IMPORTANT SAFETY NOTICE

SUBJECT: All RIDGID® 700-T2 Power Drives and Replacement Strain Reliefs (Catalog #54177)
produced between April, 2007 and August, 2007:

November 12, 2007

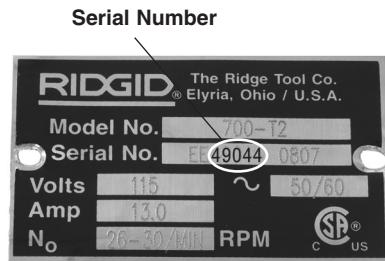
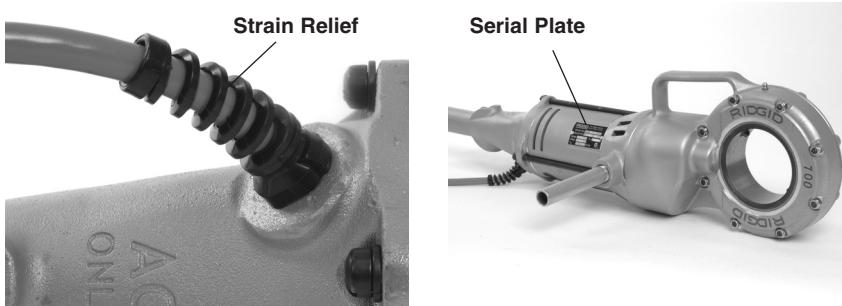
This is a Product Recall Notice. Ridge Tool recently determined that catalog # 54177 strain relief (cord connector) that retains the cord to the 700 Power Drive can cut the 700 Power Drive power cord. This could result in wire damage that could result in **severe injury from electric shock**.

All 700-T2 Power Drives produced between April, 2007 and August, 2007 are potentially effected by this issue. Affected units can be identified by examining the strain relief. This safety notice only involves strain reliefs of the design shown above:

- If the strain relief is not of the above shown design, it is not subject to this recall, and requires no action.
- If the strain relief is of the above shown design and is gray in color, the unit contains an acceptable strain relief, is not subject to this recall, and requires no action.
- If the strain relief is of the above shown design, is black in color, and the serial number falls in the range from 45519 through 49145 (as shown in the above photographs), the strain relief must be changed.

Do not use these 700 Power Drives until they have been reworked with a gray strain relief.

Contact Ridge Tool Technical Services at (800) 519-3456 or TechServices@ridgid.com for instructions to rework the affected product.
